## CHAPTER 4 SAFETY CLEARANCE, FREEBOARD AND DRAUGHT MARKS

Chapter 4 Group of Volunteers 031012

Fig. 4-4.1.2

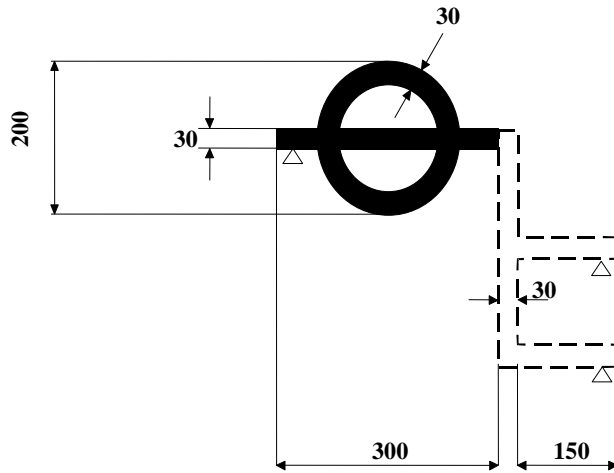
The load line for zones 1 and 2 shall consist of a ring intersected through its centre by a horizontal line which shall be supplemented if necessary by additional freeboard lines.

The width of the ring and of all the other lines of the freeboard mark shall be 30 mm; the outer diameter of the ring shall be 200 mm; the length of the horizontal line intersecting the ring shall be 300 mm; and the size of the numerals designating the zones shall be 60 x 40 mm (Figure 4-4.1.11).

The centre of the ring shall be placed amidships. The lower edge of the horizontal line which intersects the ring shall pass through the centre of the ring and shall constitute the freeboard line.

If the vessel is intended to navigate in several navigation zones, a vertical line *and* additional freeboard lines 150 mm in length shall be applied forward of the centre of the ring.

**When a vessel bears the load line, the latter is combined / fixed instead of the draught marks located amidships.**
